TP2 ADDENDUM # (4) Four

Project:	**Drayton Valley Brazeau Aquatic Centre**
Tender Package:	**TP2**
Issued By:	**Harry Hanson**
Date Issued:	**May 27, 2021**
Tender Closing:	**June 2, 2021**

Architectural Addendum No. 02
Drayton Valley Aquatic Centre

May 26, 2021
File No. 19046

19 | GRIDS 3-4 AT GRIDS H-J
SCALE: 1 : 20

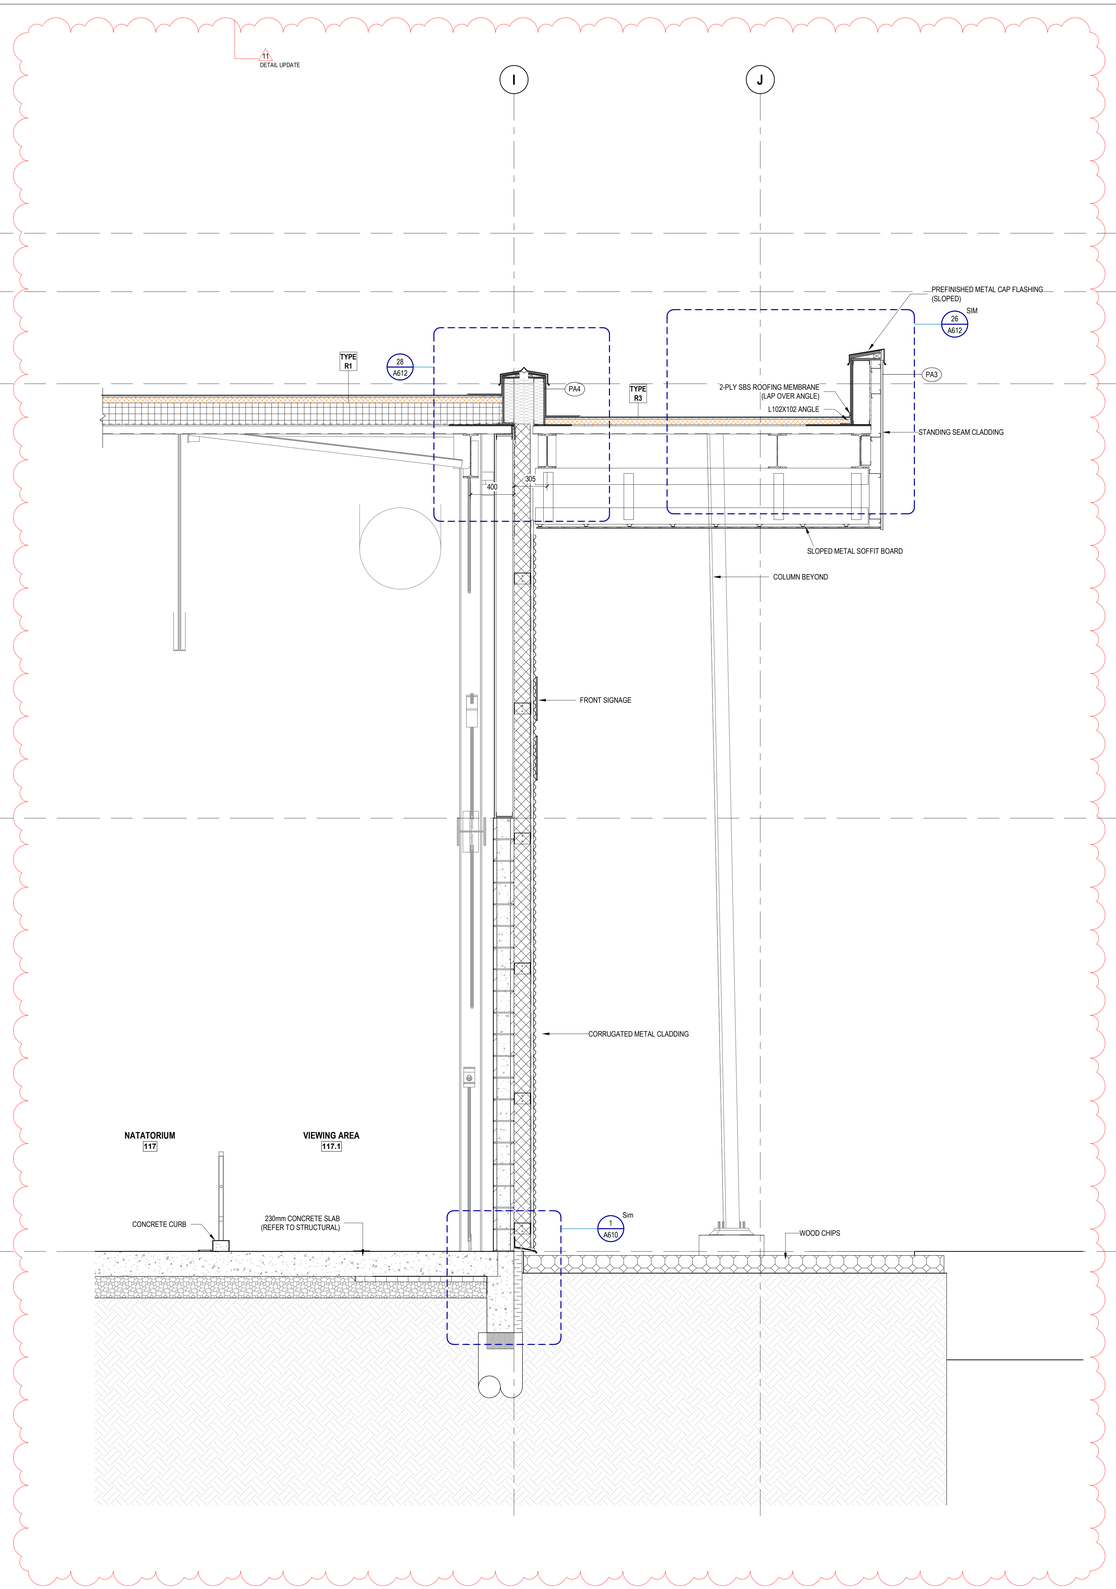
.1 **CLARIFICATION**: DETAILS #19 AND 21 - FRAMING UPDATES

24 | GRID I AT GRID 1 LOBBY ANGLED WALL
SCALE: 1 : 20

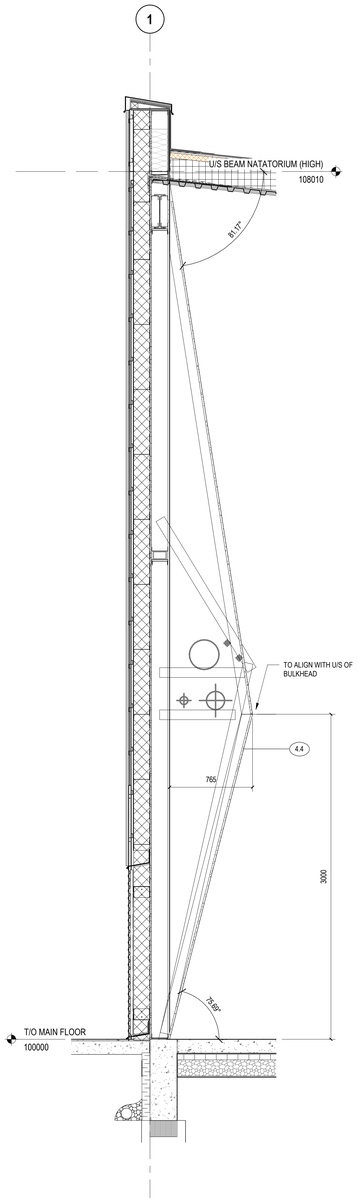
.1 **CLARIFICATION**: DETAILS #24 - FRAMING UPDATES

4 | ROOF CONNECTION @ CURTAINWALL
SCALE: 1 : 10

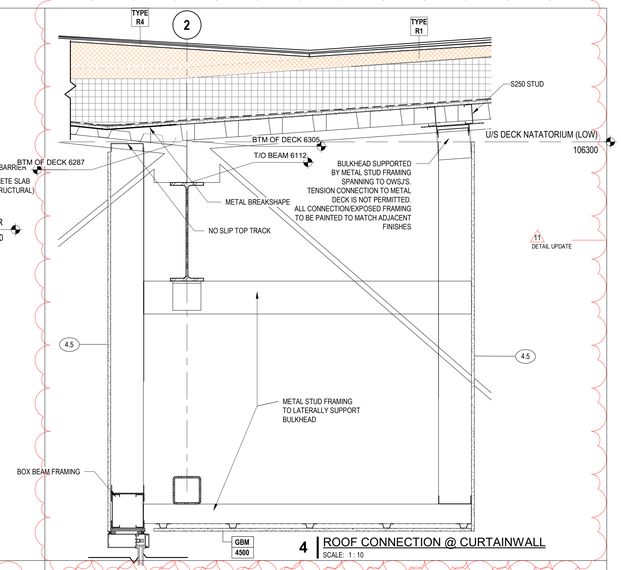
.1 **CLARIFICATION**: DETAILS #4, 7, 8, 10, 11, AND 12 - FRAMING UPDATES

19 | INVERTED ROOF DETAIL @ CMU
SCALE: 1 : 10

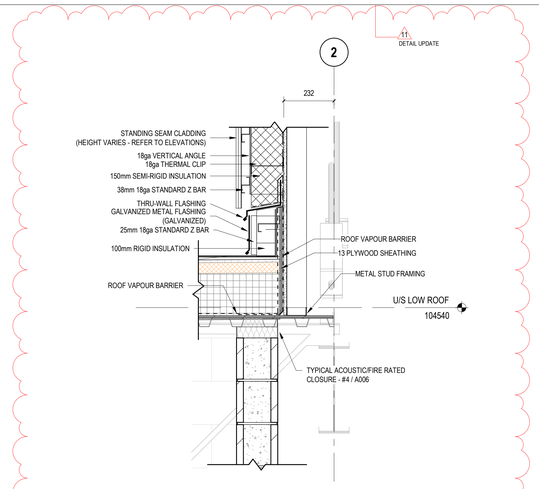
.1 **CLARIFICATION**: DETAILS #19, AND 21 - FRAMING UPDATES

25 | EXTERIOR GLAZING @ ROOF & SOFFIT
SCALE: 1 : 10 REF: A004

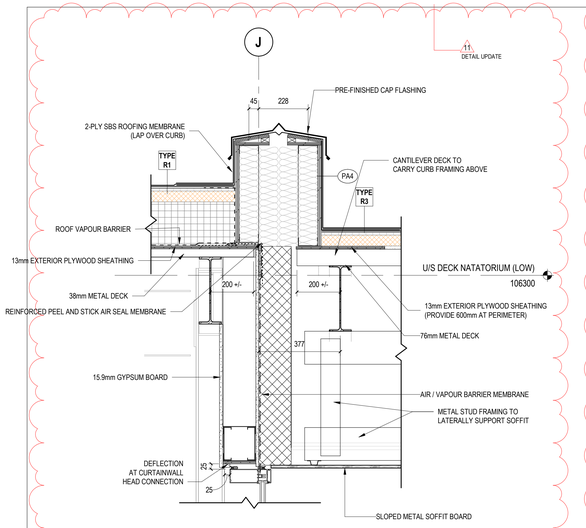
.1 **CLARIFICATION**: DETAILS #25, 26, 27, 28, AND 31 - FRAMING UPDATES
